Market Efficiency Transource Project 9A Update

Transmission Expansion Advisory Committee

June 4, 2025

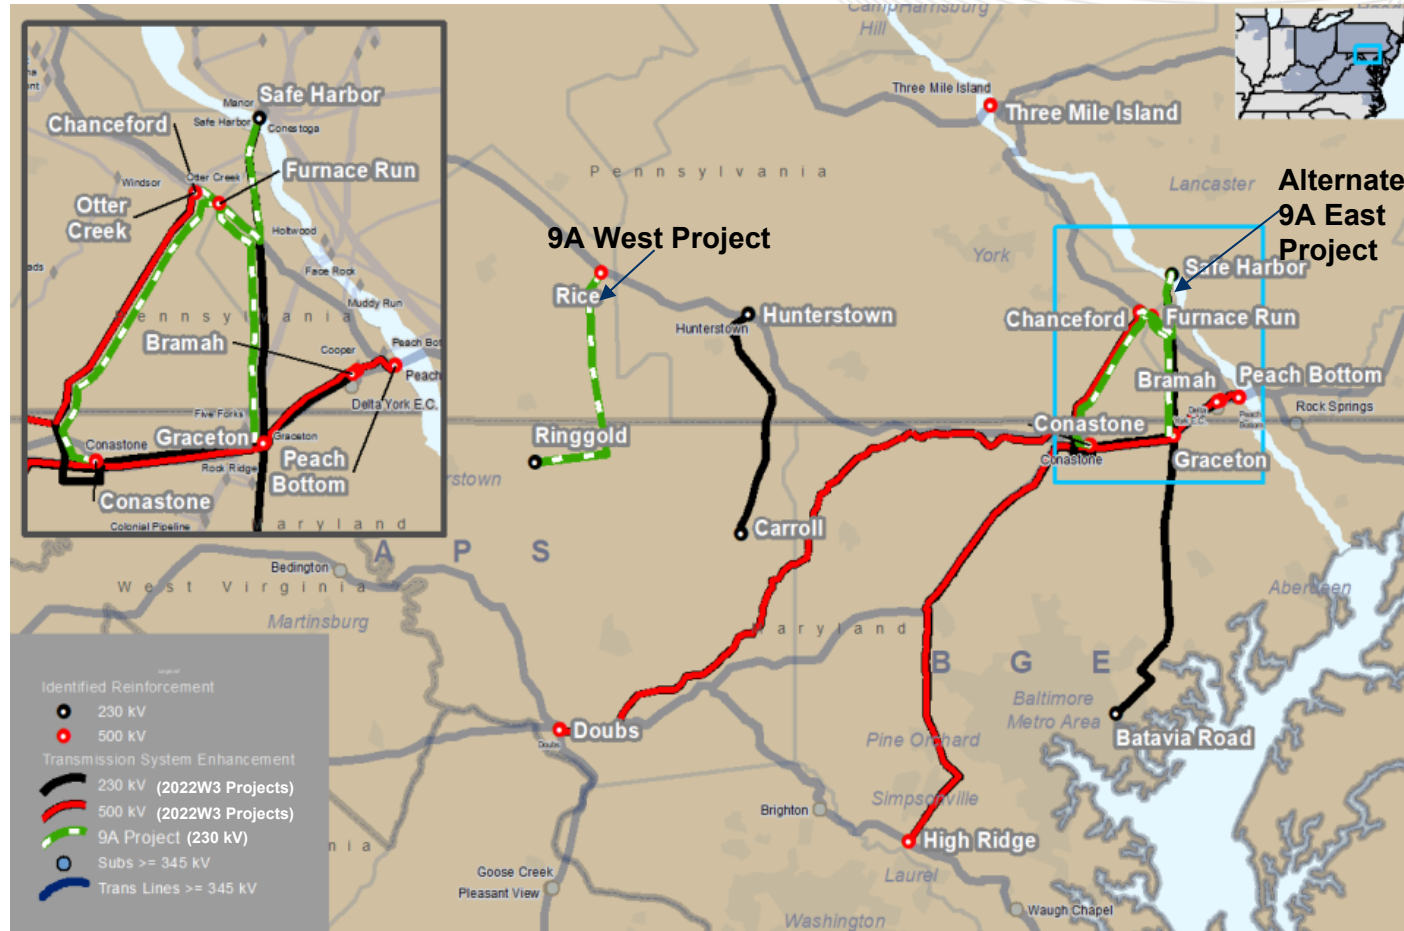
- PJM provided an update at the May 6, 2025 TEAC indicating the challenges with building the eastern portion of Project 9A (9A-East).
- Multiple RTEP projects approved after Project 9A was suspended in 2021 and some occupy the same physical location or right-of-way as 9A-East.
- Western portion of Project 9A exceeds 1.25 benefit-to-cost ratio and continues to address market efficiency planning needs on AP South and related facilities.

- Recommendation to the PJM Board in July to modify Project 9A to remove the eastern portion.
